Proposed Frontier and Wind Garden Energy Facilities,
Makana Municipality, Eastern Cape

Review of Visual Impact Assessments

20 April 2021

Prepared by
Bernard Oberholzer and Quinton Lawson

map 3 : Fronteer WEF DEFF Screening Tool

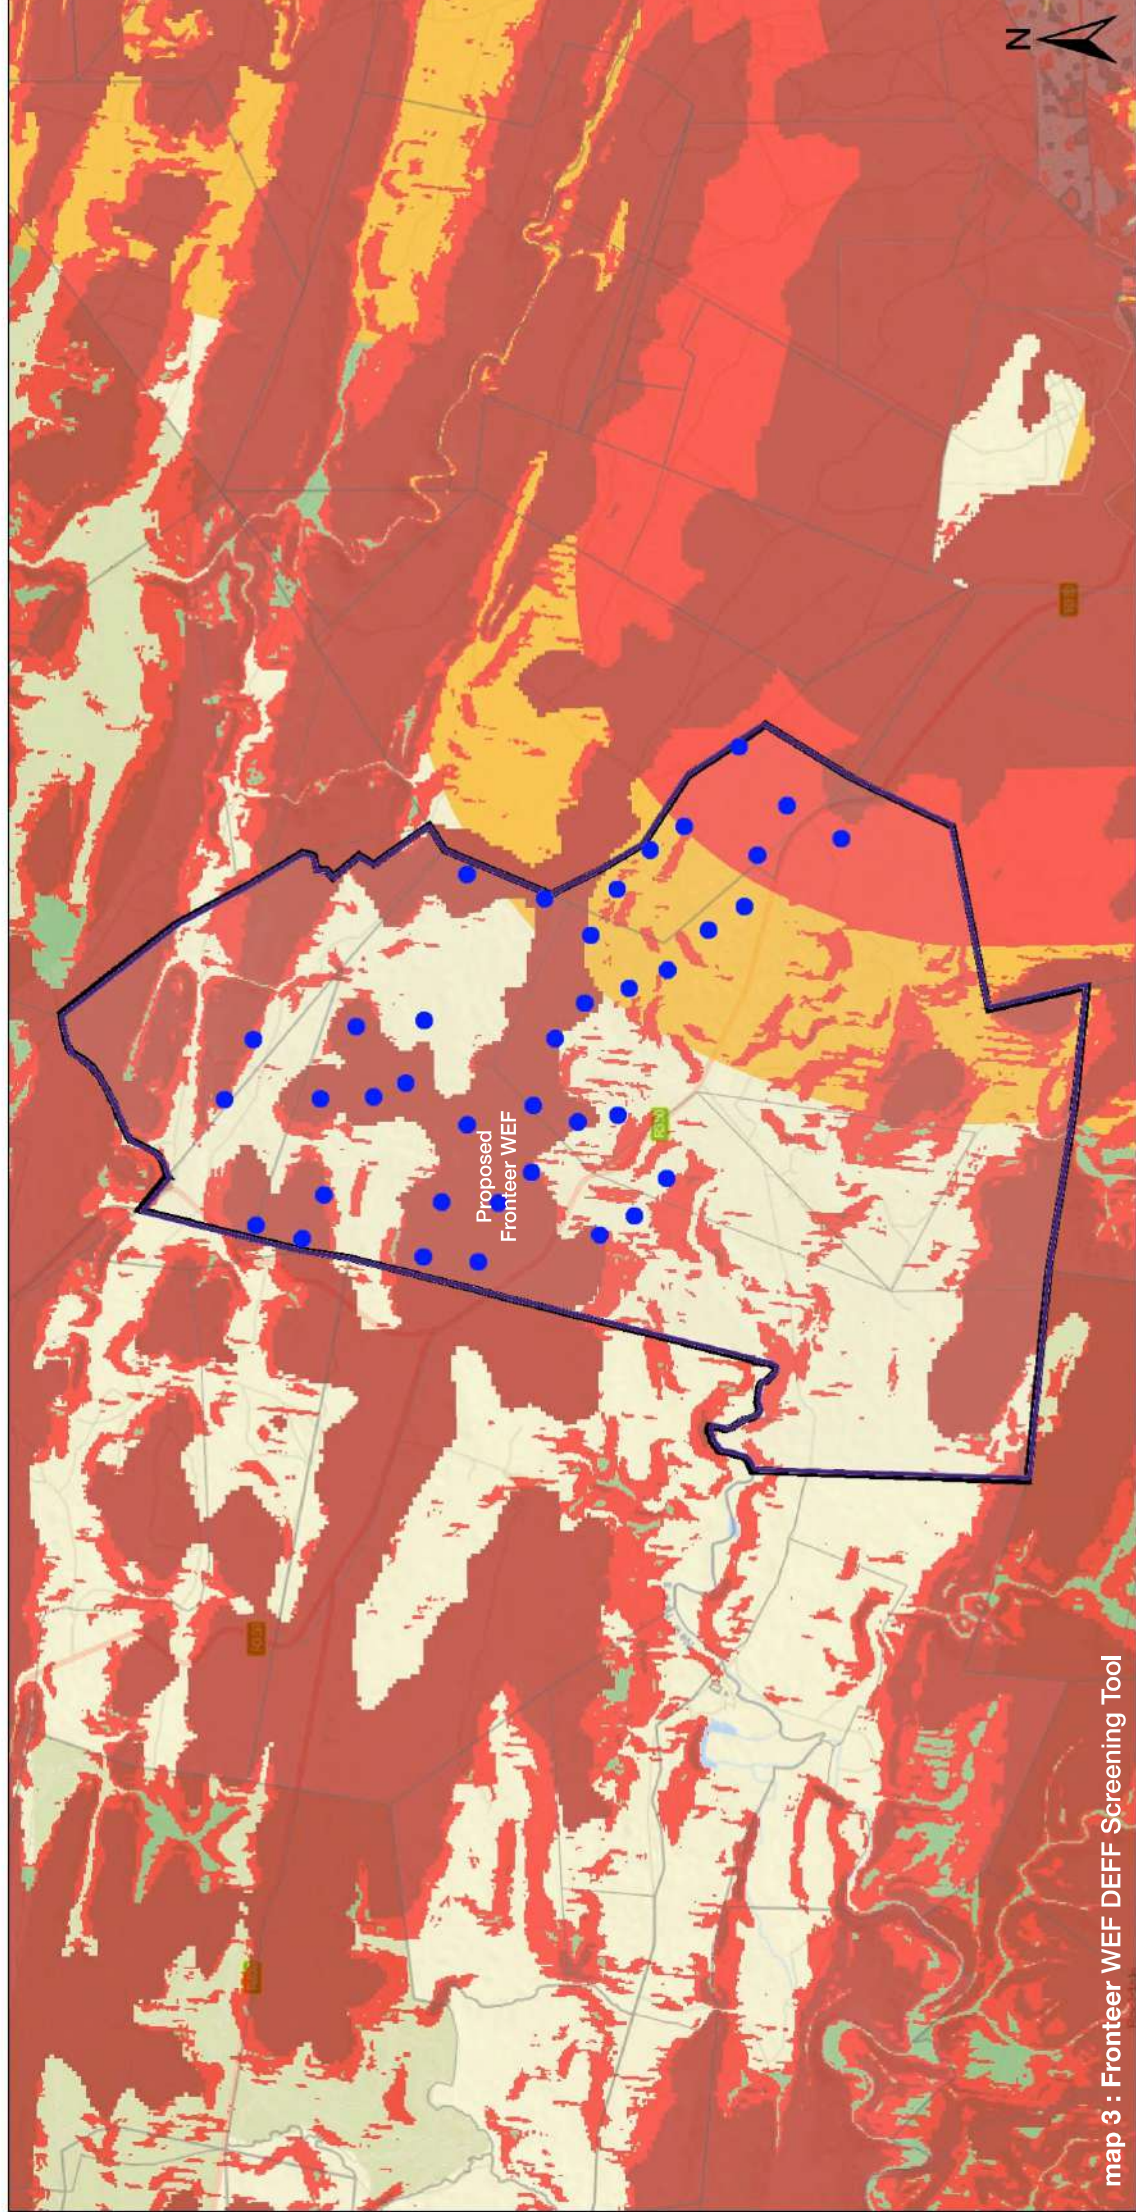
For ease of reference, the Landscape Theme (visual and scenic resources) for the Cookhouse REDZ is attached (Map3) for both the Fronteer and Wind Garden sites. The maps indicate that a number of the proposed wind turbines would occur in a 'very high' sensitivity zone. The VIA Report is then required to confirm or dispute the DEFF screening map.

map 14 : Fronteer WEF • Visual Sensitivity : Airfields 3km, Makhanda Airport 8km

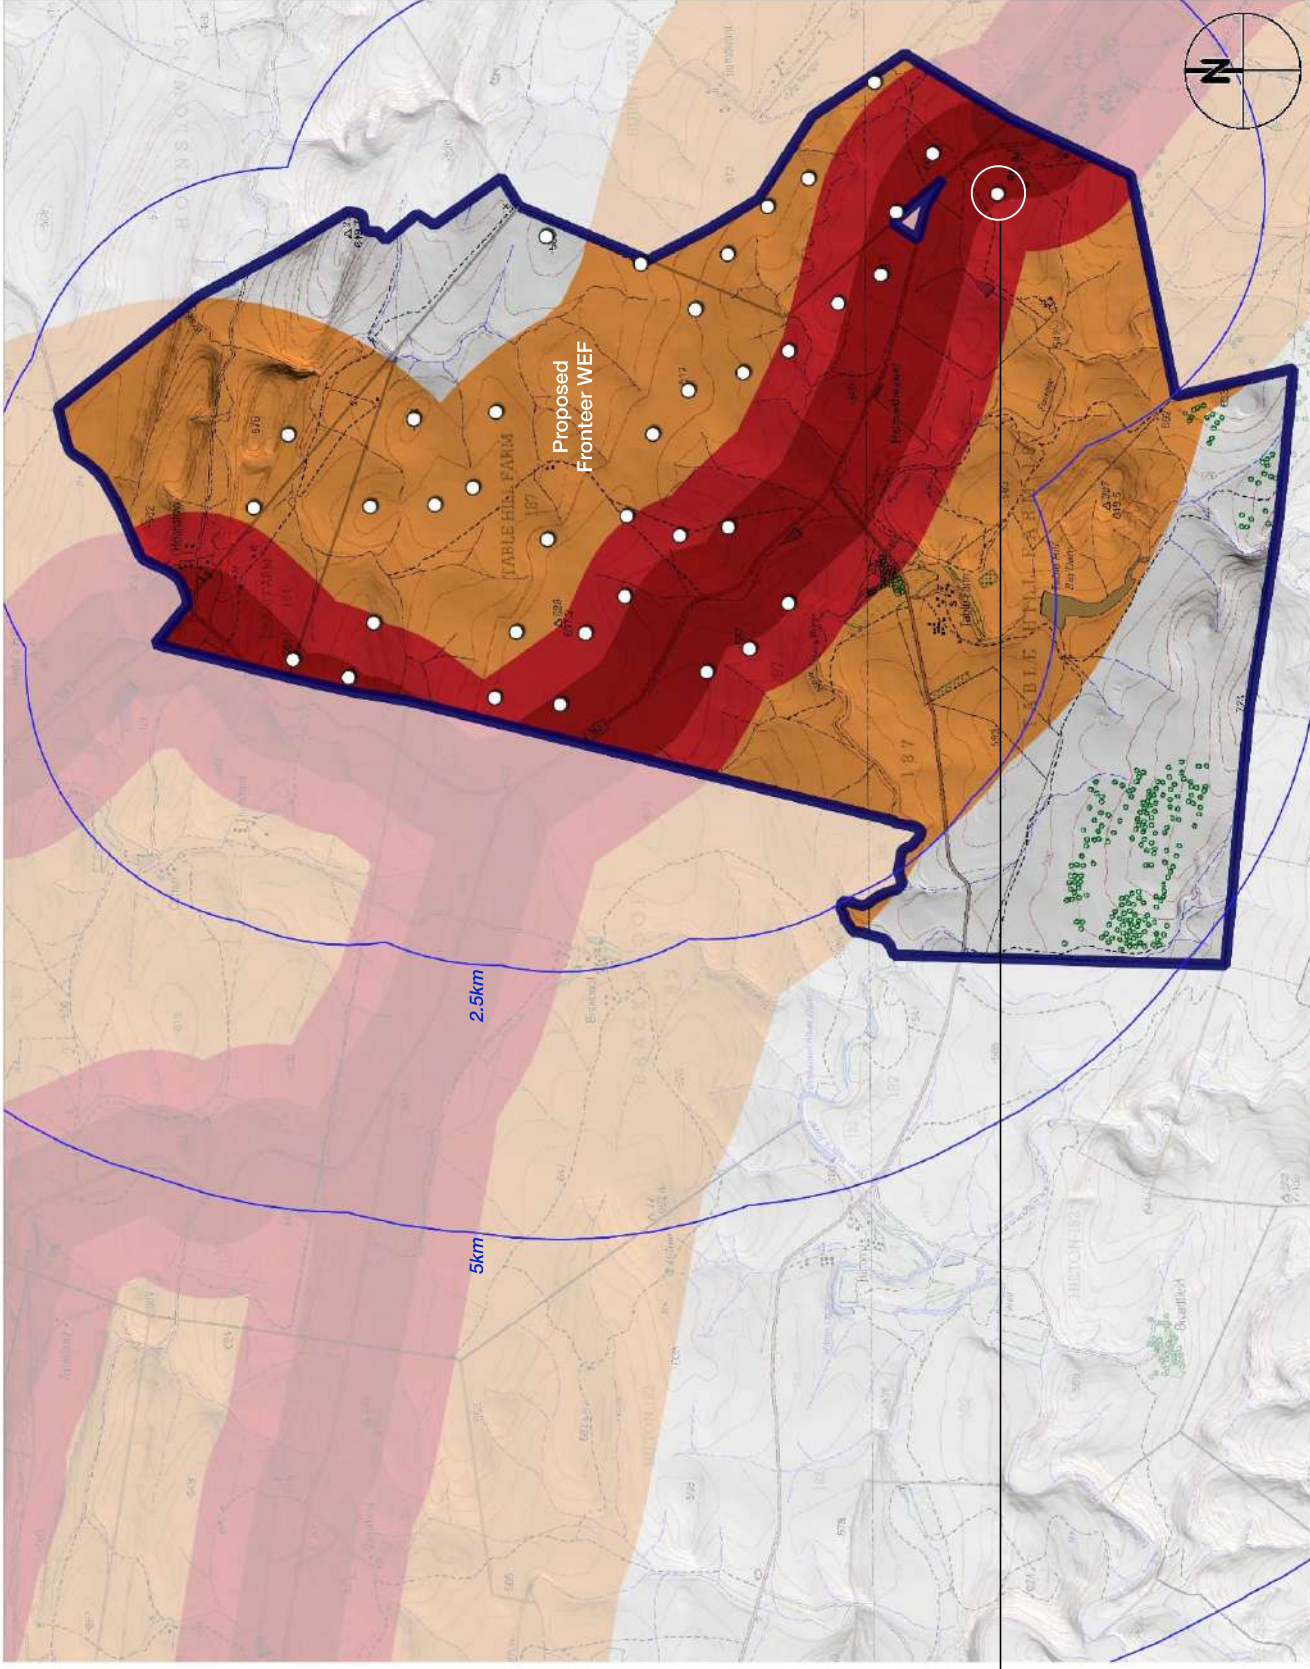
According to Regulations from The Civil Aviation Act (Act 13 of 2009), obstacle limitations need to be taken into account near airports, such as the Makhanda (Grahamstown) airport. These include the following regulation:

No buildings or objects higher than 45 meters above the mean level of the landing area, or, in the case of a water aerodrome or heliport, the normal level of the water, must without the approval of the Director be erected within a distance of 8 kilometer measured from the nearest point on the boundary of an aerodrome or heliport.

The 8km buffer is indicated on the attached Map 14, indicating that the siting of about half of the wind turbines in the proposed Fronteer Wind Farm could be affected.

map 17 : Fronteer WEF • Visual Sensitivity : Composite NoGo Areas

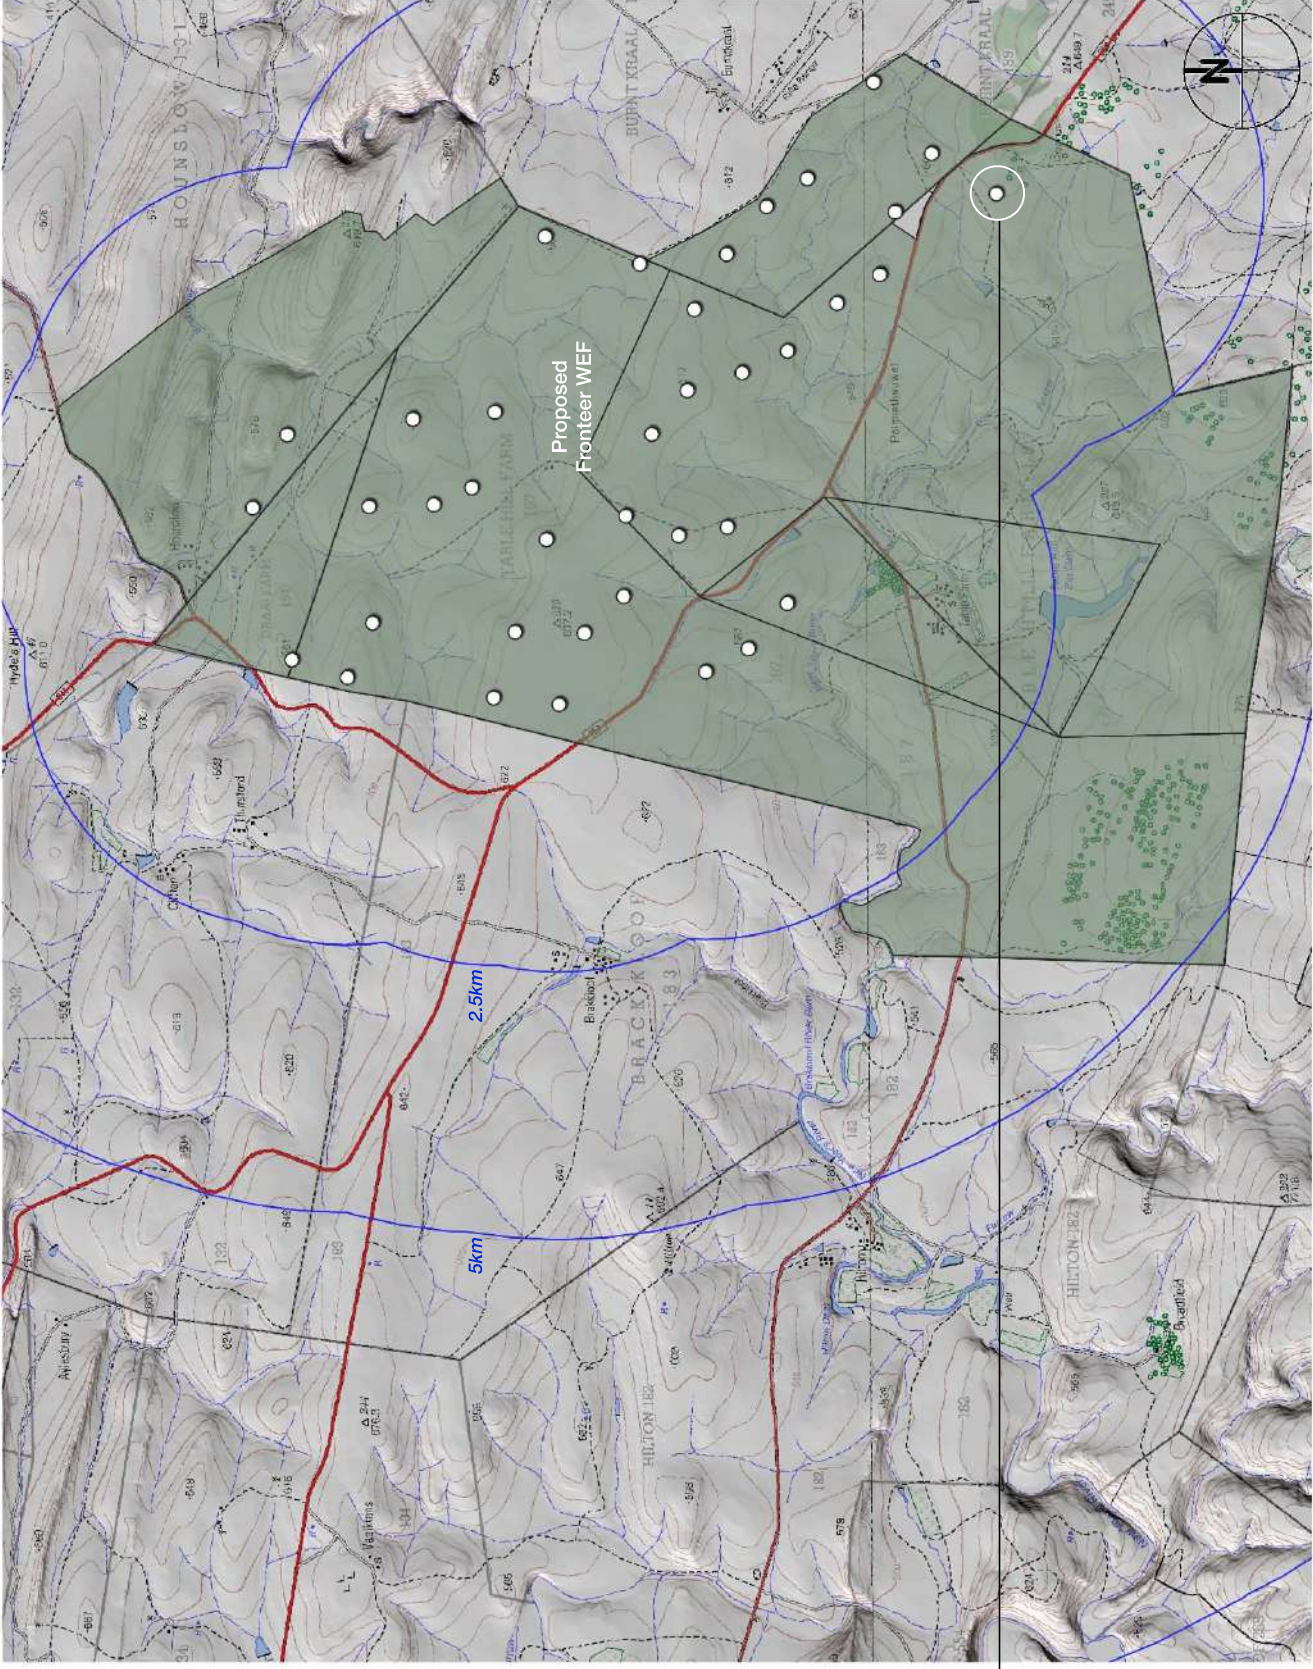
The Reviewers are of the opinion that the VIA Report contains too many omissions to warrant an informed recommendation regarding the visual acceptability of the two proposed wind farms. The desktop mapping by the Reviewers indicates that parts of the wind farm layouts are clearly problematic from a visual perspective, resulting in potential fatal flaws for many of the proposed wind turbines in both the Fronteer and Wind Garden WEFs.

Based on the desktop mapping prepared by the Reviewers, it appears that about half of the proposed Fronteer wind turbines are potentially located in no-go areas, and similarly, about a third of the proposed Wind Garden turbines are in no-go areas.

Given the scale of the wind turbines, laydown areas and related infrastructure, the most meaningful visual mitigation would be avoidance, including the use of visual buffers, which would involve the relocation or removal of turbines in visually sensitive positions. Certain wind turbine locations are patently unsuitable and would constitute a fatal flaw.
